IMPORTANT RECALL INFORMATION #60220
March 2006

SUBJECT: RECALL CAMPAIGN #60220 - KWIKEE STEP

RECALL BULLETIN:
60220

SUBJECT:
Inspection and Correction of Entry Step Controller

Figure 1
Affected Controller
(Requires Replacement)

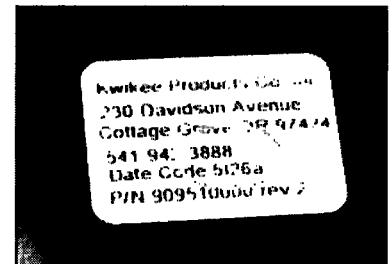
On motor homes affected by this recall, the Kwikkee brand electric entry step, built with a control unit manufactured by American Technologies Corporation may develop an electrical short during cold weather, (temperatures below 10 degrees Fahrenheit), causing the plastic case to ignite, making the step inoperable and possibly resulting in risk of personal injury, vehicle and/or other property damage.

3. Examine the label on the step controller unit, mounted to the step frame.
 - A) If the motor home is equipped with a step controller displaying a date code ending in "a", as shown in Figure 1, a new Step Controller with Diode Harness (Kit Part #478178) must be installed. Proceed with the Repair Preparations section of this Bulletin, Step 4.

Follow the procedure below for motor homes equipped with a step controller displaying a date code ending in “a”, as shown in Figure 1.

7. Unplug the 4-wire step controller plug from the Fleetwood harness.
8. Unplug the 2-wire step controller plug for the step motor.
9. Unplug the purple wire from the porch light circuit.
10. Unplug the black wire from the under-step light circuit.
11. Remove the ground screw and star washer from the step frame. Retain the ground screw for later reinstallation. Discard the old star washer.
12. Remove the ground bolt at the motor home frame rail. Retain all grounding hardware for later reinstallation.

Figure 2
Correct Controller
(No repair necessary)

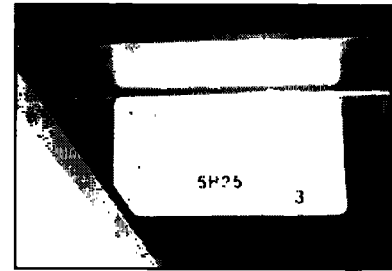
- B) If the motor home is equipped with a correct step controller as shown in Figure 2 (with date code **not** ending in “a”), no further repairs are necessary for this Recall.

Figure 3
Diode Harness Connections

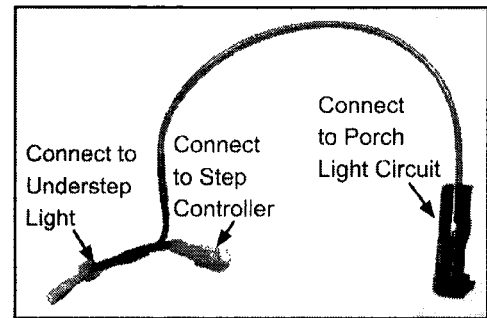
- Install a Diode Harness by performing the following: (See Figure 3)

- Connect the wire from the under-step light to the mating connector on one of the diode harness black wires.
- Connect the black wire from the Step Controller to the mating connector on the remaining black diode harness wire.
- Plug the moisture resistant connector on the diode harness purple wire into the porch light circuit.
